# UNITED STATES PATENT AND TRADEMARK OFFICE

APPLICATION NO.	FILING DATE	FIRST NAMED INVENTOR	ATTORNEY DOCKET NO.	CONFIRMATION NO.
10/762,695	01/22/2004	Jorge L. Orbay	HAN-030	5249
36822	7590	10/25/2006	EXAMINER	
GORDON & JACOBSON, P.C. 60 LONG RIDGE ROAD SUITE 407 STAMFORD, CT 06902			ISABELLA, DAVID J	
			ART UNIT	PAPER NUMBER
			3738

## Office Action Summary

*Fig. 1*

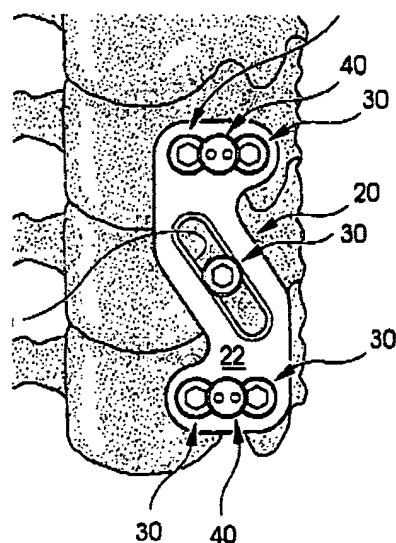
Claim 10, see hole in shaft portion as shown in figure 1.

Claims 15, see four holes in figure 1.

Claim 18 see shaft portion as illustrated in figure 1.

Claims 31,33-35, see figures 1 and 5 supra.

*Fig. 5*

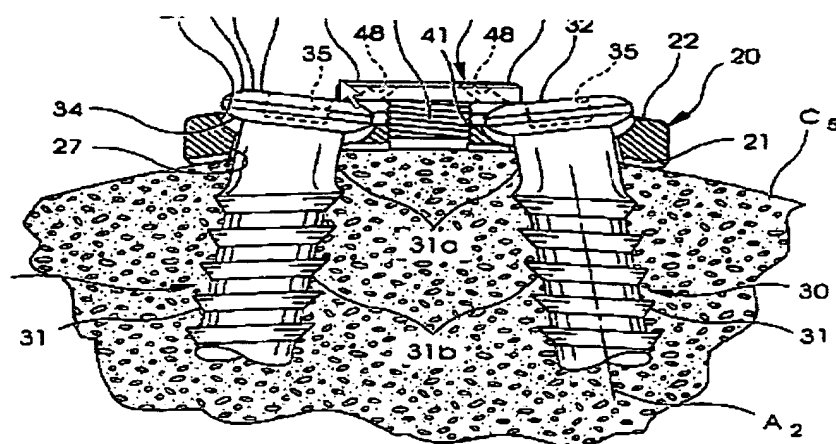
Head portion contains the series of apertures 30 and the shaft portion has the elongated slot formed therein. The cooperation of the bone screws with the apertures allows the screws to be divergent and obliquely angled with respect to each other.

Claim 44, see figure 5 supra.

Claim 2 and 3 see figure 5 and corresponding portion of the specification.
